From: Drummond, Richard
Sent: Thursday, 13 September 2012 5:18 PM
To: [REDACTED]
Subject: RE: Land Sale - Tender Docs Block 20 Section 34 Dickson
Attachments: RFT Block 20 Section 34 Dickson 13 Sep 2012.pdf; Contract for Sale Block 20 Section 34 Dickson.pdf; Special Conditions Block 20 Section 34 Dickson.pdf; PDA Block 20 Section 34 Dickson 13 Sept 2013.pdf; Proforma Deed of Unconditional Undertaking.pdf; Attachment B - Block 20 Section 30 Dickson - Layout Plan.pdf; Attachment C _LDA Urban Design Guidelines_Dickson S34.pdf

RE: Draft Territory Plan Variation 311 (Dickson Group Centre Precinct Code)

From: [REDACTED]@thetradies.com.au]
Sent: Thursday, 18 October 2012 11:44 AM
To: Dawes, David
Cc: Drummond, Richard; Ellis, Greg
Subject: Block 20 Section 34 Dickson
Attachments: 2012 10 18 Initial Questions on RFT.pdf

FIGURE 1 – OPTIONS TO TRAVEL BETWEEN DICKSON PLACE AND BADHAM STREET

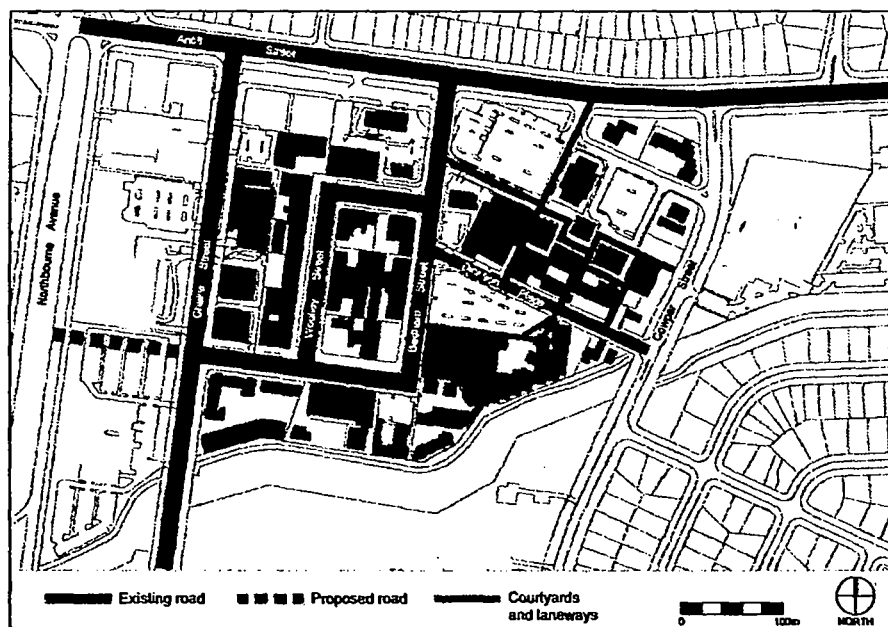
The proposals presented in the RFT documentation and their relationship to the Proposed Precinct Code require clarification. ***Specifically the RFT documentation does not advise whether the laneway access along the southern edge of Block 20 is required in place of, or in addition to, the road described by the proposed Precinct Code.*** If the laneway access is required in place of the road described by figures 3 and 10 of the Precinct Code, the need for Control 29 of the Precinct Code falls away. Control 29 should likewise fall away, or its terms and supporting figures revised to make it clear that the proposed laneway access required by the RFT meets this requirement.

In our previous representation we noted a possible error in Control 29; the control currently refers to an indicative cross section for Badham Street, whereas it might be more appropriate to refer to Figure 12 which comprises an indicative cross section for the 'Cape Street extension'. We requested that this be

clarified. Either way, the layouts illustrated on the RFT's Proposed General Arrangement Plan and in the 'Intended Design and Development Outcomes' do not marry with any of the indicative cross sections contained in the Proposed Precinct Code. This leads us to the conclusion that the proposed laneway access is required *in addition* to the proposed road.

If this is the case, ***we query the underlying urban design rationale and benefits that these proposals will bring to Dickson Group Centre.*** While supportive of proposals to increase connectivity within the Centre, the relative benefits of progressing both proposals appear minimal. If implemented, the proposals will provide an additional two roadways through Section 34, providing vehicles with three separate options for traversing the approximate 200 metres between Cape Street and Dickson Place. Pedestrians will have the fourth option of traversing through or around the edge of the pedestrian plaza. The provision of a greater number of connections does not necessarily result in greater connectivity, and may in fact undermine urban design outcomes by altering the road pattern and relationship of blocks relative to one another.

FIGURE 2 – PROPOSALS CONTAINED WITHIN THE DICKSON URBAN PLANNING & DESIGN FRAMEWORK

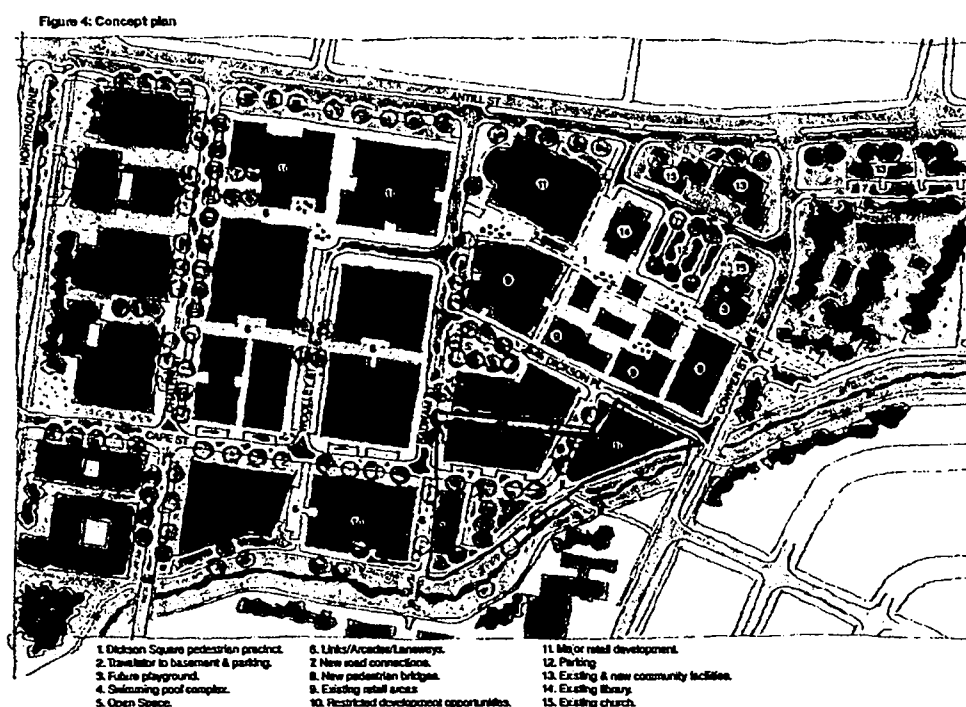
scoped with TAMS, and if so, what the impact of additional intersections (with additional queuing locations) will have on traffic flows within this part of the centre.

1. Whether the RTF proposals are in addition to or in place of the requirement to provide a connecting road between Cape Street and Dickson Place as per Control 29 of the Proposed Dickson Centre Precinct Code.

2. If the RFT proposals are in addition to the Precinct Code requirements, the urban design considerations underpinning this proposal including any public consultation undertaken, and any advice received from TAMS regarding the traffic management implications of the proposal;
3. If the RFT proposals satisfy the requirements of Control 29 of the Proposed Precinct Code to provide a connecting road between Cape Street and Dickson Place, confirmation that Control 29 will either be deleted as having been satisfied, or amended to make this clear.
